SPECIAL NOTICE

Communications Specialists

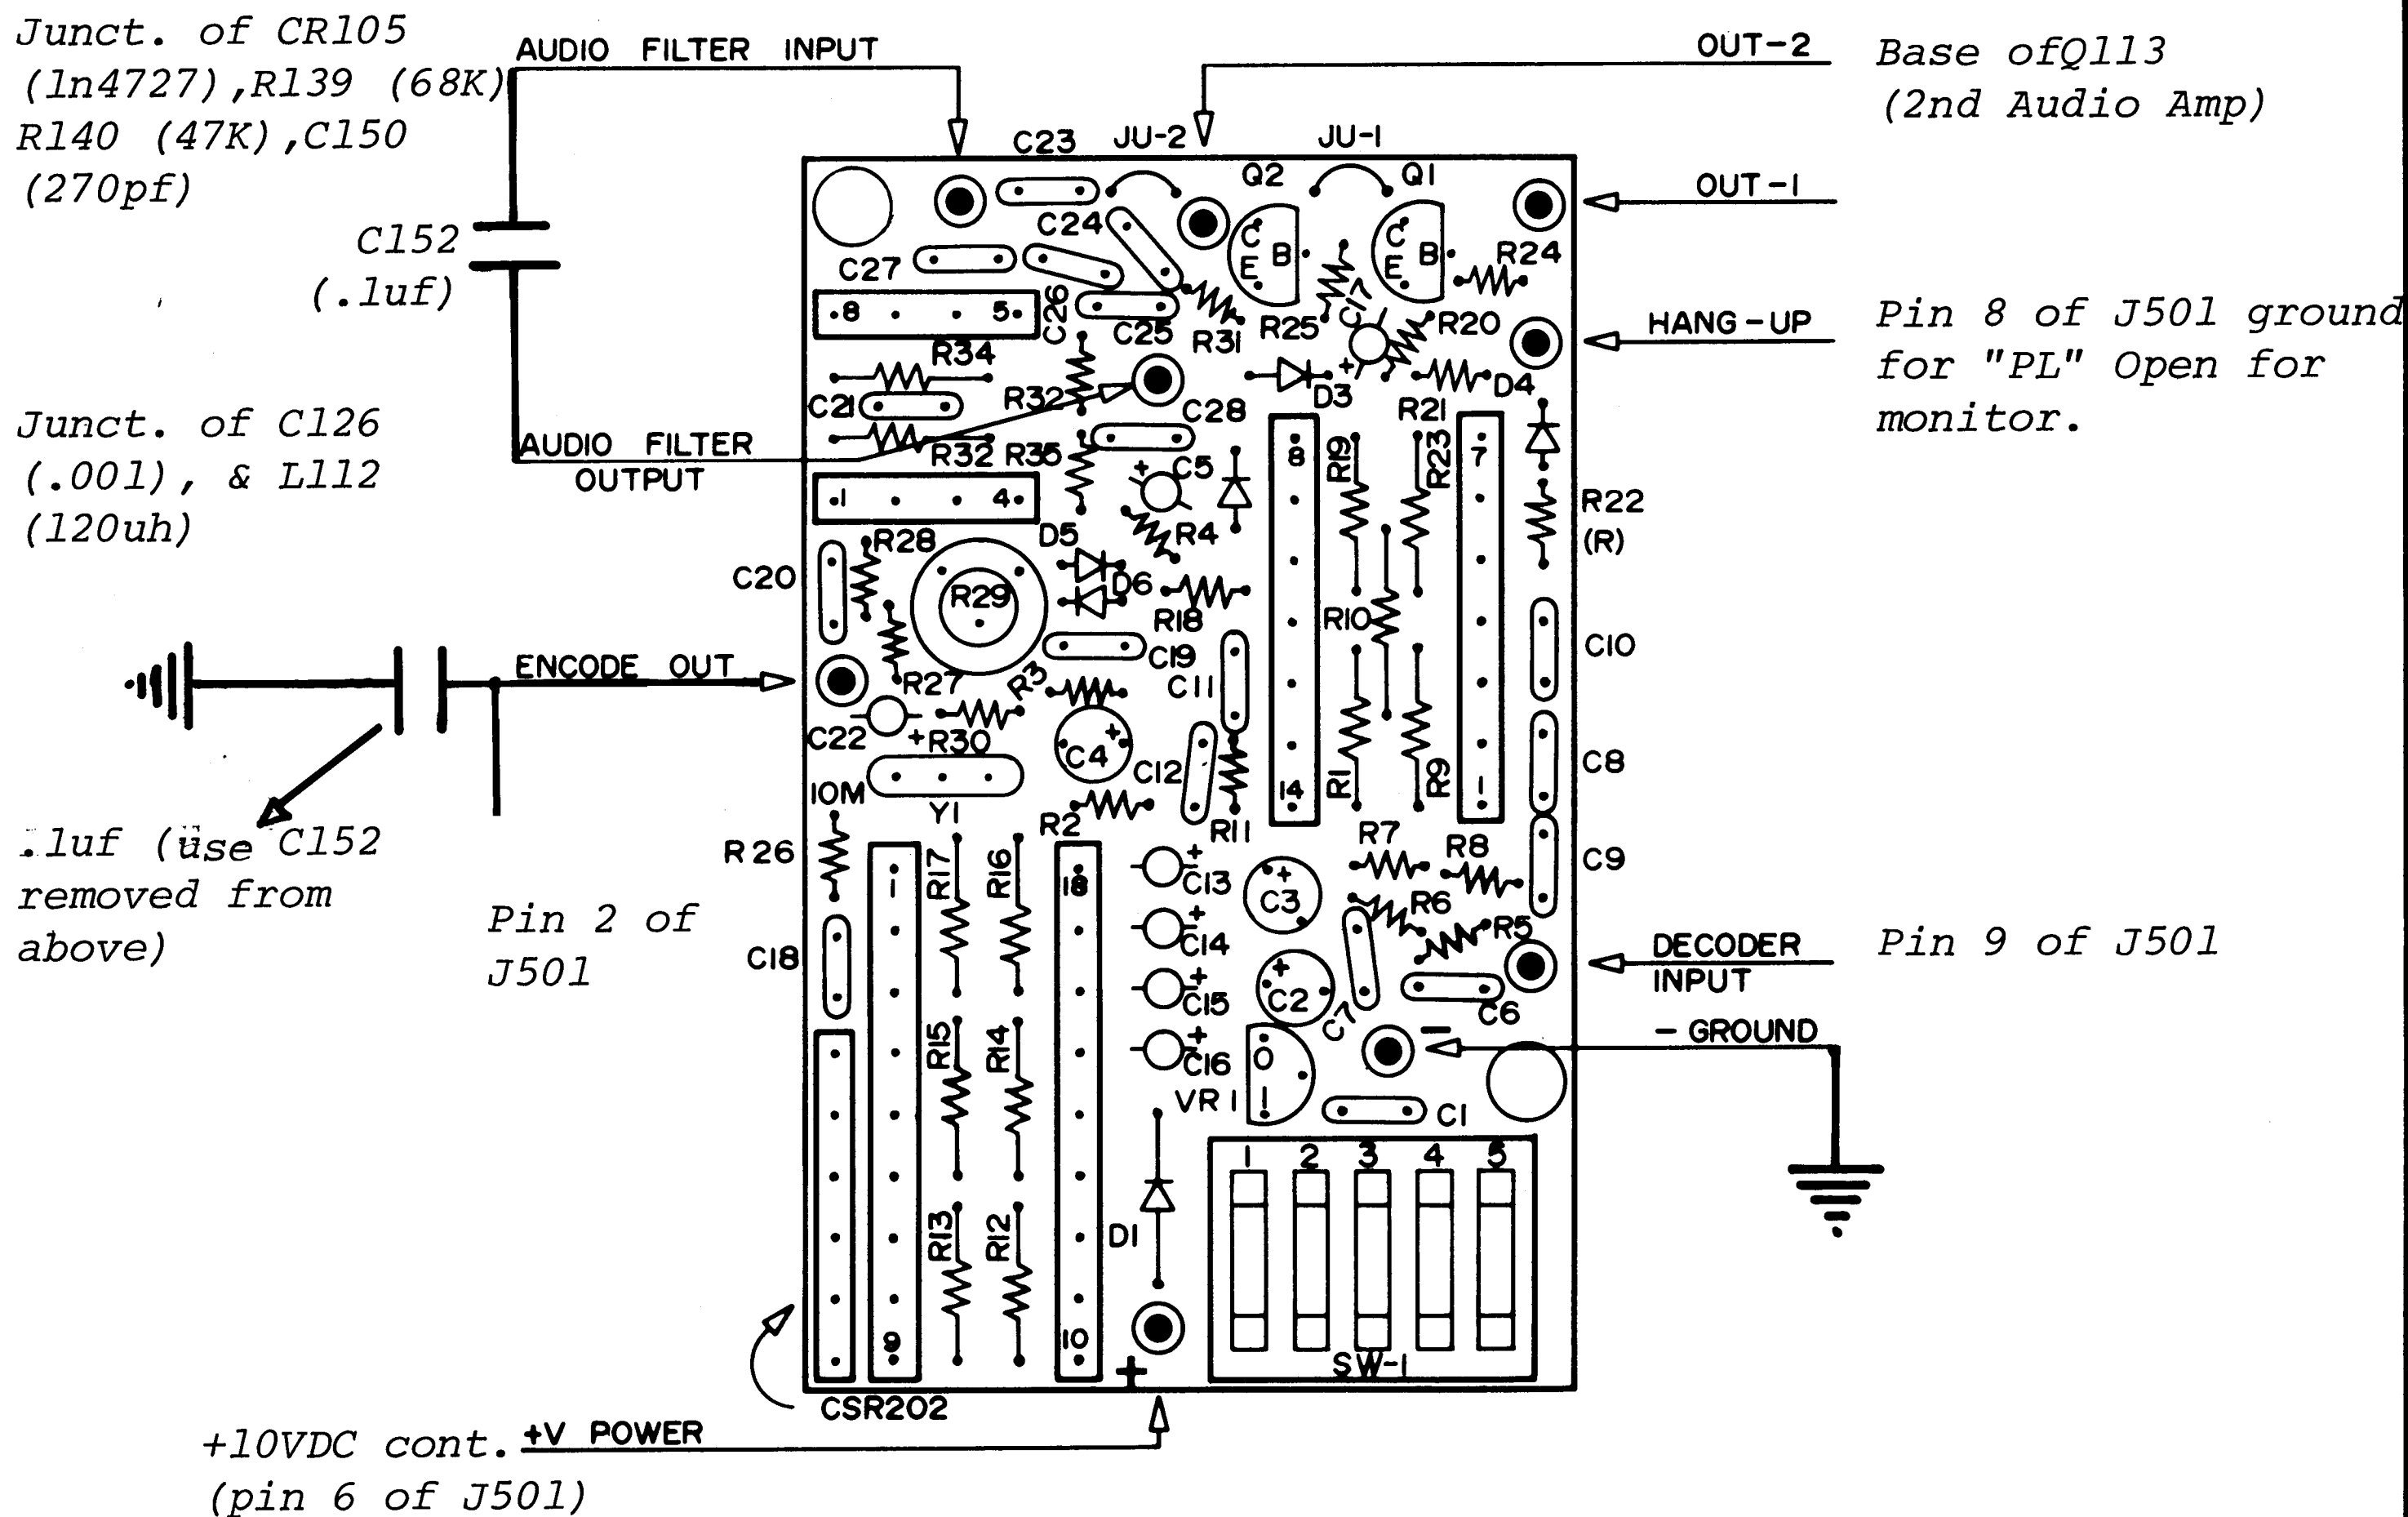
WHEN MOUNTING THE TS-32 WITH A 90 DEGREE ANGLE BRACKET AGAINST THE PCB, BE SURE TO USE THE TWO FIBER SPACERS PROVIDED BETWEEN ANGLE BRACKET AND PCB. IF THIS IS NOT DONE, THE BRACKET WILL SHORT OUT FOILS ON THE PCB

JU-1 (in)
JU-2 (out)

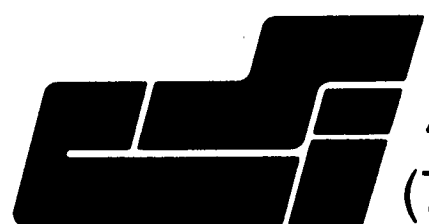
If you are using the audio filter try leaving in JU-2 instead of clamping the squelch with OUT-1 or OUT-2 as shown on the hook-up.

or

If there is a tendency for the audio filter to oscillate, try a 4.7 to 10K resistor in series with the audio filter output
